# Safety Notice

# SN661

Models Affected: TL17iSA

SUBJECT: Hydraulic control manifold o-ring failure

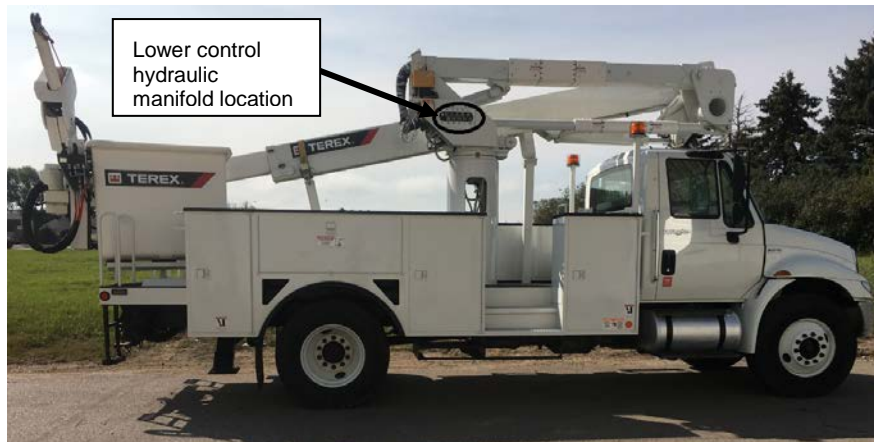
Terex is aware that hydraulic fluid may bypass a control valve spool in the boom hydraulic control manifold. An issue during the machining process may contribute to o-ring failure causing this hydraulic leakage inside the control valve spool. **If an o-ring failure occurs on a valve spool in the hydraulic control manifold, inadvertent boom movement may occur.**

In-line valve spools = This bulletin applies

Staggered valve spools = This bulletin does **NOT** apply

Terex will provide a replacement hydraulic control manifold for units that have the affected hydraulic control manifold as shown.

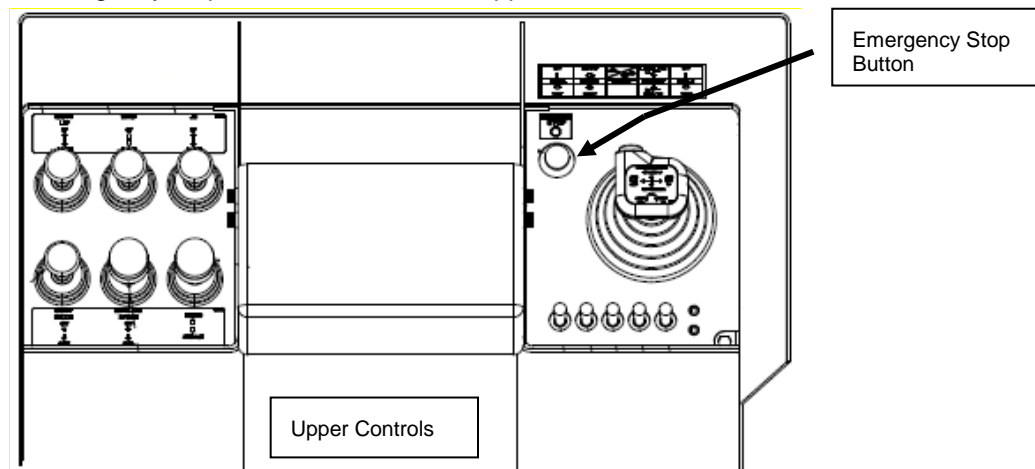
3. If your unit has the in-line valve spools on the hydraulic control manifold, this bulletin applies. Follow the continued use section below.
4. If your unit has the staggered valve spools on the hydraulic control manifold, this bulletin does not apply and use can continue without restriction.

- 1) Inform all users, operators, and supervisors to follow the procedure below in the event there is hydraulic leakage around the o-ring and inadvertent boom extend movement occurs:
  - A) Press the emergency stop button located at the upper controls.

- B) Verify the engine has shut off.
  - C) Lower the platform with the auxiliary letdown circuit.
  - D) Store the unit and remove the unit from service until the hydraulic control manifold is replaced.
- 2) Always follow all inspection and maintenance requirements as specified in the manuals.
